UNITED STATES OF AMERICA
NUCLEAR REGULATORY COMMISSION

(Bloomsburg)
Site Decontamination))

NRC STAFF'S RESPONSE TO LICENSING
BOARD'S QUESTIONS EXPRESSED DURING
CONFERENCE OF APRIL 19, 1991

**FIGURE 1.
LOCATION
MAP**

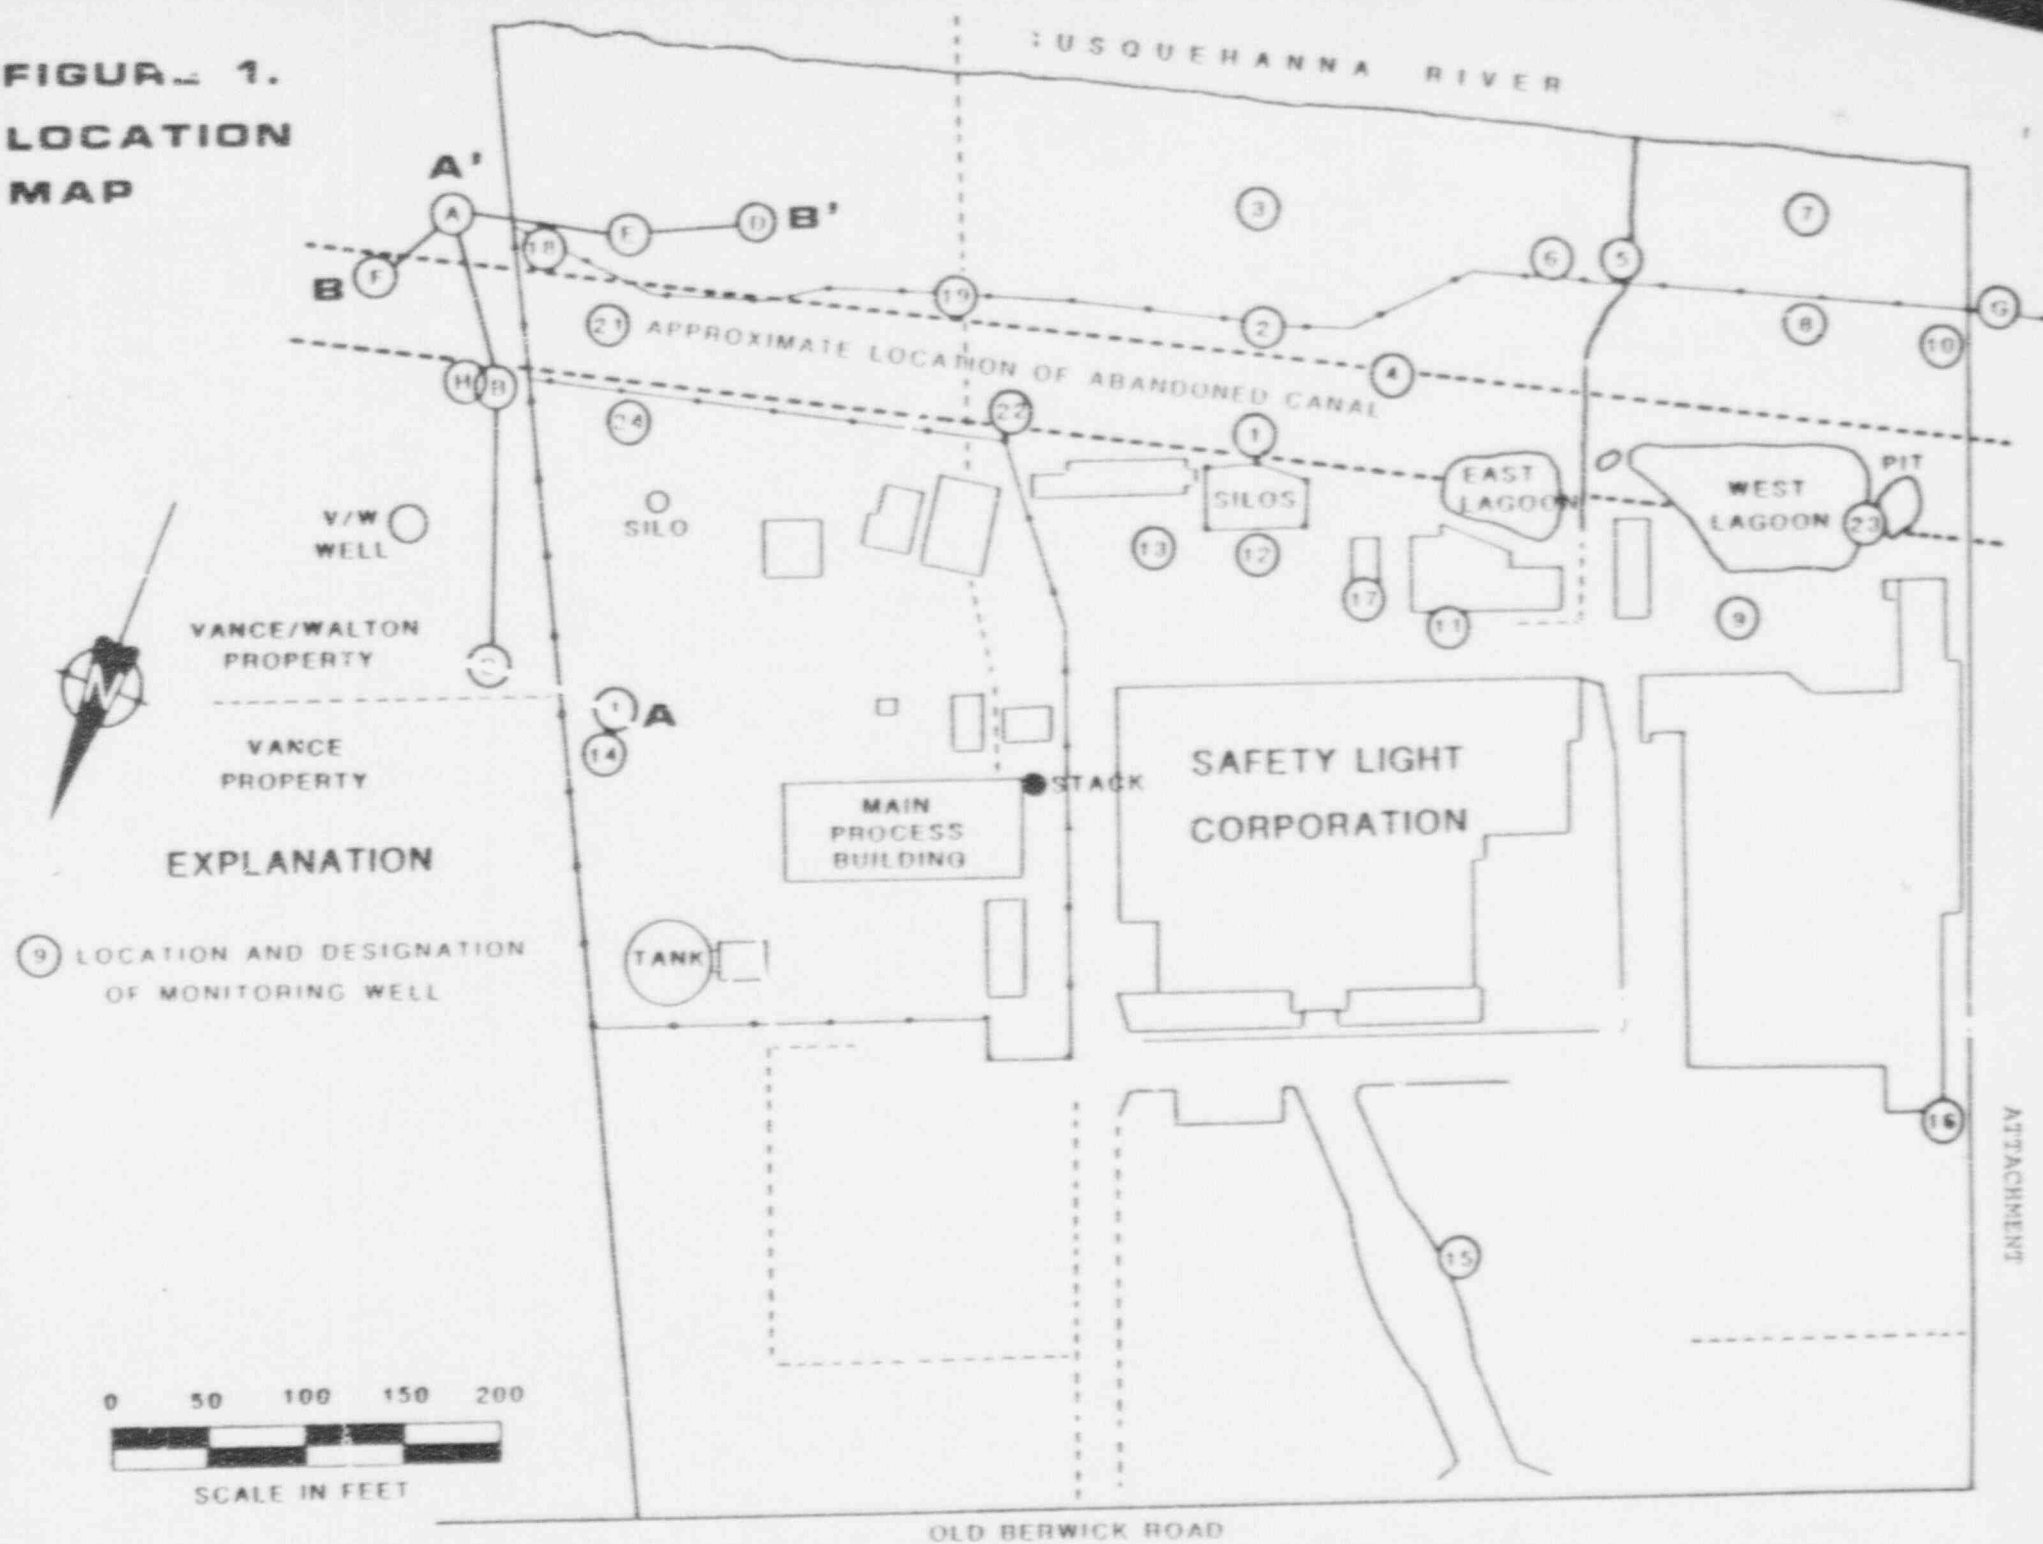
- b. Characterize and, if necessary, remove contaminated material (including any hazardous constituents) in the canal, two lagoons, and the waste pit (the area marked "pit" west of the West Lagoon as shown on Figure 1 in the October 1990 Chem-Nuclear report, attached). It is still unclear if the source of the Sr-90 groundwater contamination on the Vance-Walton property is the silos or Sr-90 contaminated material in the canal. A waste pit has been identified in the western portion of the canal; it is possible that this pit is leaching contamination to the off-site area to the west, although the domestic well to the west of the site has not shown elevated levels of radioactivity.
